Advisory Action Before the Filing of an Appeal Brief

Application No.	Applicant(s)		
10/674,739	BALL, WILLIAM T.		
Examiner	Art Unit	_	
Robert M. Fetsuga	3751

CAP FOR FALING A BATHTUB OVERFLOW FOR TESTING PURPOSES

Fig. 1A

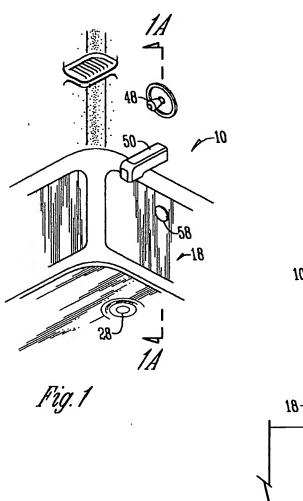
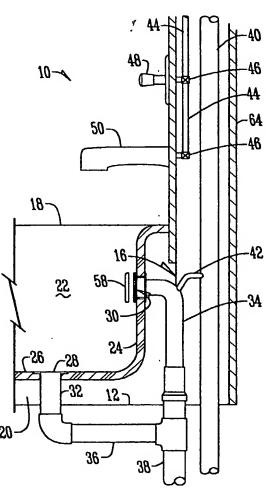
Continuation of 11. does NOT place the application in condition for allowance because: Pipe 42 not present in 10/247,247 (copy of Fig. 1A attached hereto). Term 'hollow stub tube" not present in instant application at filing.
